**CHASSIS FRAME**

CATEGORY 3A MODIFICATION.

WELDED FRAME STIFFENERS.

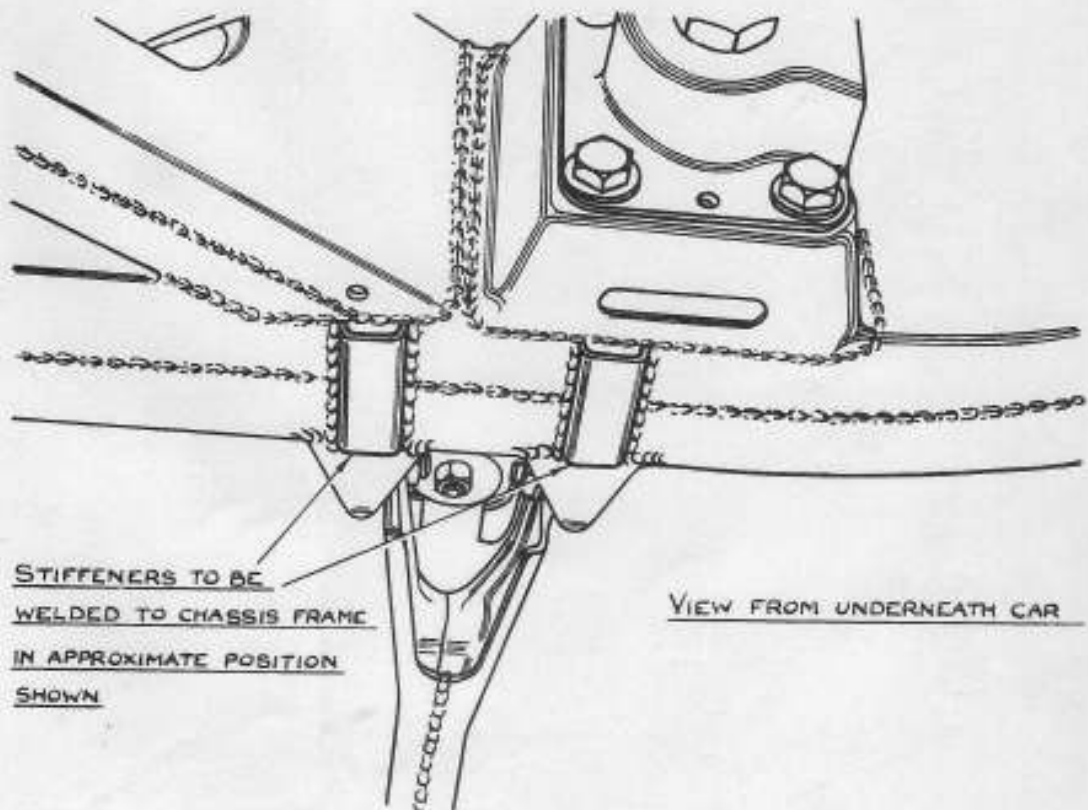
On certain cars it may be found that when raising the car with the car jack provided, the jacking spigot "springs" relative to the frame, and it may even be possible in extreme cases for this to damage the frame.

To prevent any "springing" at the jacking point and to overcome any possibility of damage to the frame, stiffening pieces are to be electrically welded to the underside of the frame adjacent to the jacking points as illustrated.

In the unlikely event of damage to the frame, which will be evident in the form of a split in the welding along the underside of the frame, the frame is to be welded electrically. It is neither desirable nor practicable for these components to be gas welded.

<u>Part No.</u>	<u>No.Off.</u>
Chassis Frame Stiffener	UR.3305.	4.

Rolls-Royce Silver Cloud - All chassis up to SZB-204.  
Bentley "S" Type Saloon - All chassis up to 456-CK.  
Bentley "S" Type Continental - All chassis up to BC-27-BG.

MODIFICATION TO THE FUEL TANK MOUNTING STRAP  
INTERMEDIATE BRACKET.

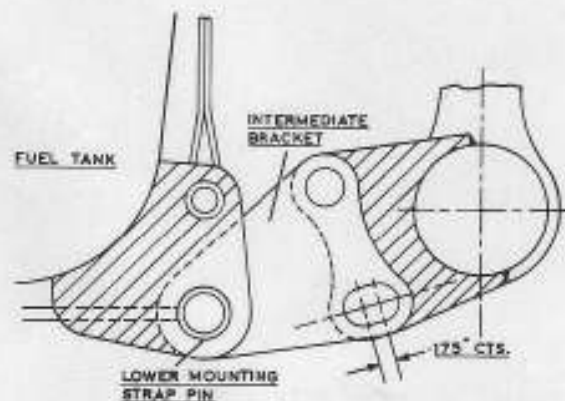
It may be necessary on certain cars to lower the rear of the fuel tank so that the wiring loom fitted to the undersurface of the boot floor cannot be chafed between the top of the fuel tank and the undersurface of the boot floor.

Raise the rear right hand road wheel and remove it to inspect whether sufficient clearance exists between the upper surface of the fuel tank and the undersurface of the boot floor. If the wiring loom shows signs of being chafed it must be replaced, or if the clearance is inadequate, the four rear mounting intermediate brackets are to be modified.

Support the fuel tank in such a manner that it cannot be damaged by its own weight and so that the load is removed from the mounting straps. Disconnect the mounting straps by removing the two lower-most strap pins, one each side, and withdrawing the lower straps from the strap pins by removing the two adjusting nuts. Remove the intermediate bracket securing nuts and bolts and elongate the lower bolt holes as indicated.

Replace the brackets and strap pins leaving the intermediate bracket fixing bolts loose until the fuel tank mounting shoes have been positioned to allow the tank to assume the correct clearance from the undersurface of the boot floor. Inspect to ensure that the fuel tank does not foul elsewhere. It will be necessary to relieve the fuel tank support to facilitate this operation, but leaving it close in position for safety.

Refit the lower mounting straps in the strap pins and tighten the intermediate bracket fixing bolts, finally inspect to ensure that the clearance has not altered afterwards.

<u>MATERIALS.</u>	<u>Component.</u>	<u>Part No.</u>	<u>No.Off.</u>
	Split Pin	K.4608/Z	4.

Rolls-Royce Silver Cloud all chassis up to SBC-136.
